City of Arvada

SUBJECT: A Variance from the rear yard setback requirement for 8430 Clara Belle Dr. for the construction of an Accessory Dwelling Unit (Casaletto ADU)

**COMMUNITY AND ECONOMIC
DEVELOPMENT DEPARTMENT
BOA STAFF REPORT**

Case No.: VAR2026-0001

Figure 6: Site plan from [Figure 4](#) showing 5 foot fire separation distances (per IRC §R302) in red. As explained in the text, we would require costly fire-rated construction and/or retrofit if we observed a 10 foot rear setback and kept the ADU layout the same.

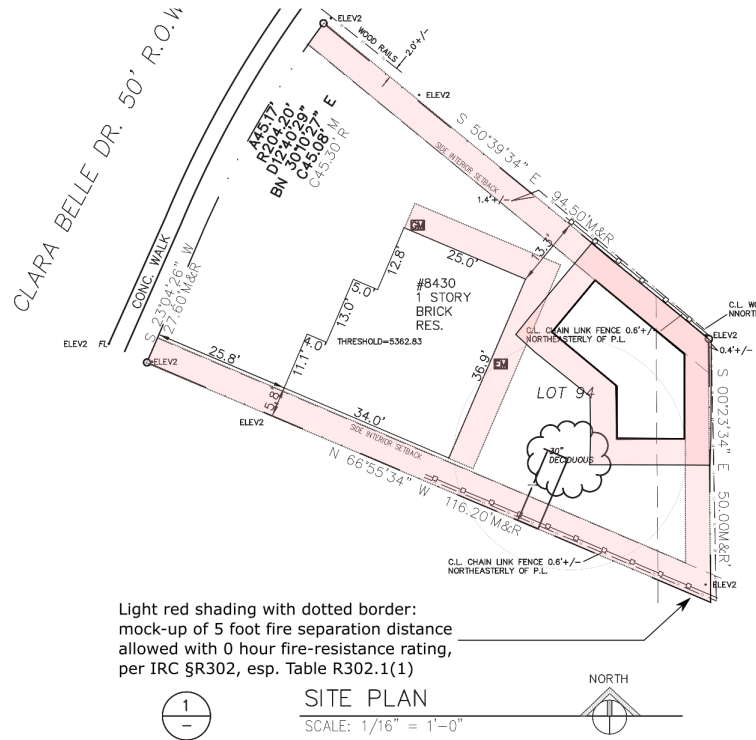
- a. If we tried to maintain the same ADU footprint shown in the preliminary site plan, the resulting fire separation distance (< 10 feet; see [Figure 6](#)) between the primary residence and the ADU would require fire rated construction and/or retrofit per IRC §R302. Our builder has provided us with a cost estimate (attached) indicating that providing such construction for both the ADU and existing primary structure would add at least \$18k to the project cost. It would also add significant uncertainty and delays, as retrofits would need to be made to the existing structure prior to construction of the ADU, and there may be unseen factors in the existing structure that would complicate the retrofits if started. We believe this outcome is a peculiar and undue practical difficulty.

Figure 7: Site plan from [Figure 4](#) showing potential new water and sewer runs to the ADU. As explained in the text, we would require difficult and impractical utility runs if we both observed a 10 foot rear setback and sited the ADU towards the southeast corner of the lot

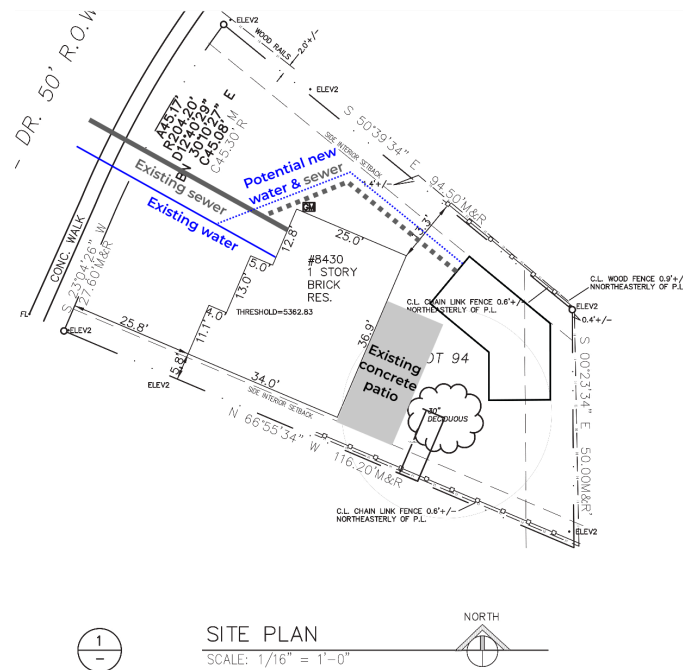
- c. If we moved the ADU to the southeast corner of the lot to avoid footprint reductions *and* fire rating requirements, we would create an undesirable backyard space where:
 - i. There would be direct sight lines between the windows and doors of the primary residence and ADU, creating a lack of privacy and uninviting living situation for us and all future residents. We believe this is a particular and unnecessary hardship.
 - ii. Sewer and water lines for the ADU would have to be significantly longer in order to tie into existing lines, or would have to be routed beneath an existing concrete patio and through the foundation of the existing primary residence (see [Figure 7](#)). We believe this is a peculiar and undue practical difficulty.
